Rezoning Transportation Analysis

Petition Number: 2022-216

Date	Description
05-24-2023	First Review (JP)
11-27-2023	Second Review (TP)
12-19-2023	Third Review (IW)

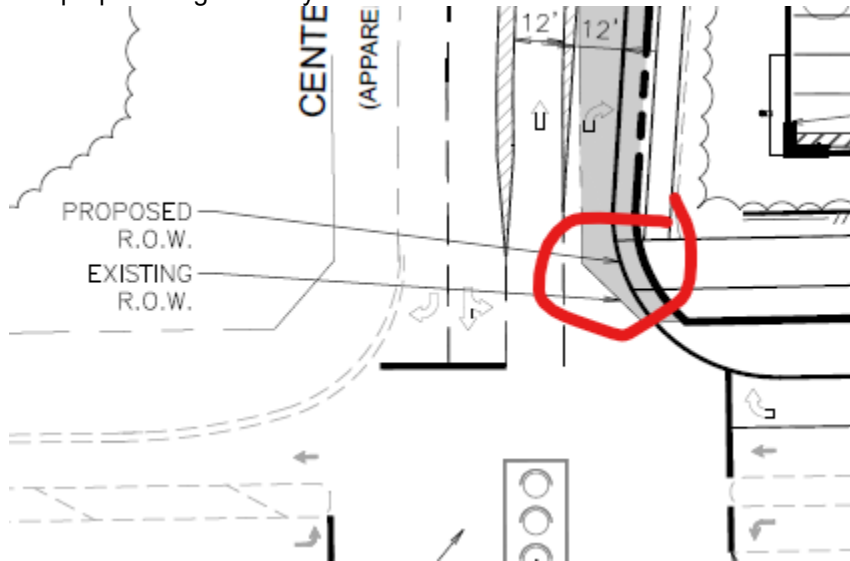
4. Revise site plan and conditional note(s) to commit to dedicate 35 feet of right-of-way from the road centerline on Sam Wilson Road. The site plan shall label and dimension the right-of-way from the road centerline.

Clarifying comment 11.27.2023: Label and dimension right-of-way from roadway centerline on Sam Wilson.
